Software Update Notification
DPS70 Software File Updates for Rev B Hardware
June 1, 2023

Updated NeRP Files

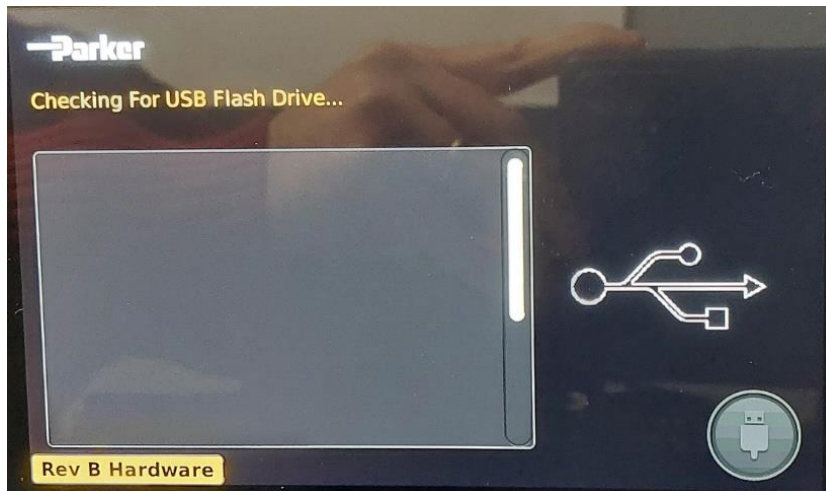
Parker Hannifin Corp has made an internal change to the FPGA chip used inside the DPS70 Instrument Panels. This change does not affect the performance or operation of the DPS70. However, this change has necessitated a new release of the software that is loaded into the DPS70 units.

This new version is designated as the Revision B Hardware.

There are two ways to identify the new hardware versions. The first will be visible on the part number label as noted in the image to the left. The text “Rev B” will be noted next to the model number.

New software files are available that are compatible with both the Rev B hardware, and the previous revisions of hardware. These new software files will have similar naming conventions but will have the words “Rev B” at the end of the file name. The new software files can be loaded into both the old revision

hardware and the new, Revision B, hardware. However, the old software files cannot be loaded into the new, Revision B, hardware. If an attempt is made to load the old software into the new Revision B hardware, an error message will appear.
